Request for Quotation

RFQ NUMBER
 DEP13009

HUNT COAL U-5071-86
ADDENDUM #1

CHANGES TO SCOPE OF WORK AND BID SCHEDULE

OFFICE OF SPECIAL RECLAMATION	
RESTRUCTURED STREAM CHANNEL	
SCALE:	DRAWN BY:
DATE:	PROJECT NO:

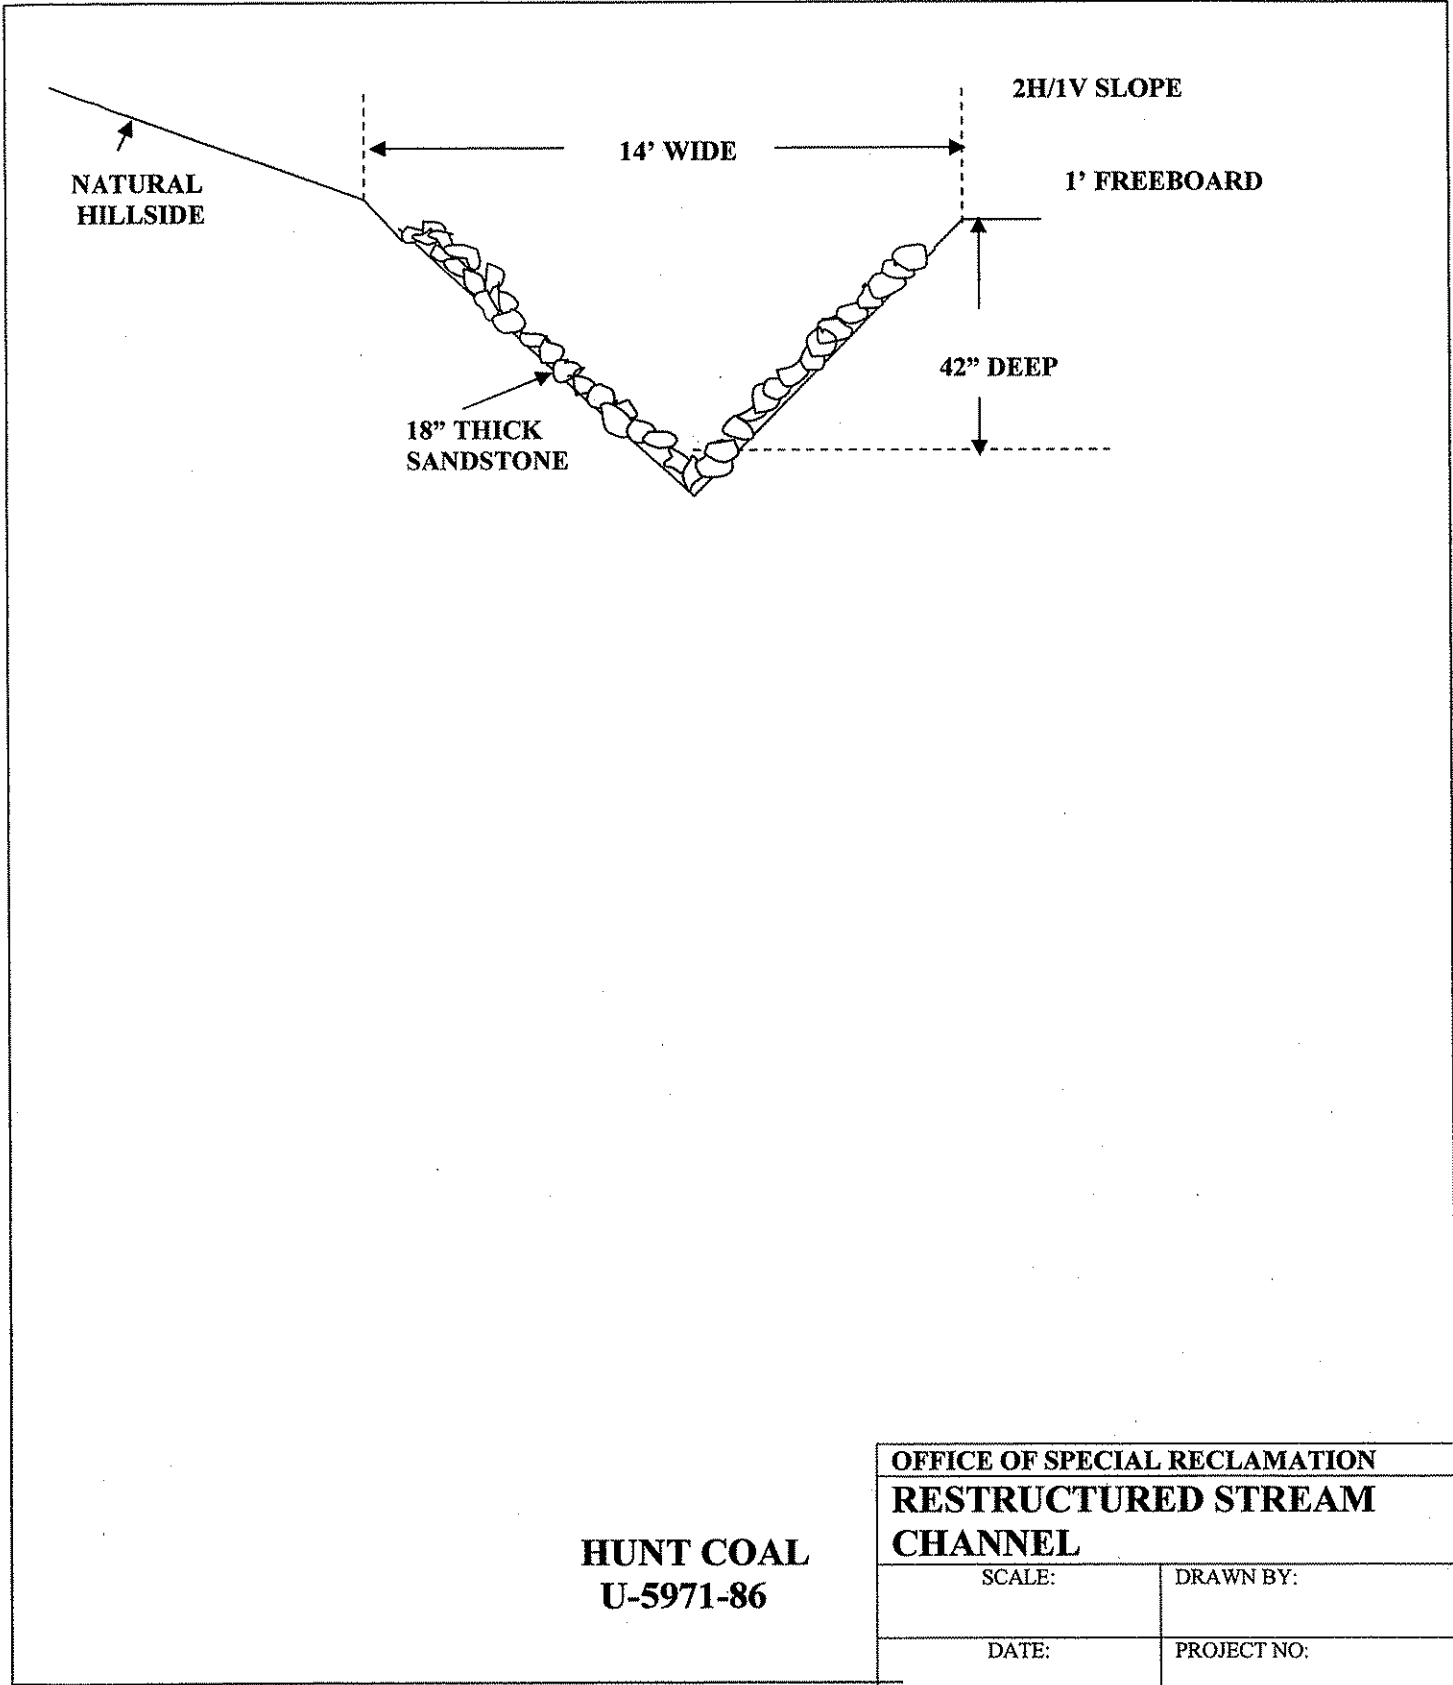
- 27) A new typical for TREATMENT UNIT FENCE, page 100, will replace the one in the package, and will be called FENCING AQUA-FIX/STILLING BASIN.
- 28) A new typical, on page 106, RESTRUCTURED STREAM CHANNEL, has been added. If needed, the stream channel above the valley fill can be restructured to a V-ditch configuration according to attached specifications. The ditch can be lined with the sandstone that is present in the stream channel.
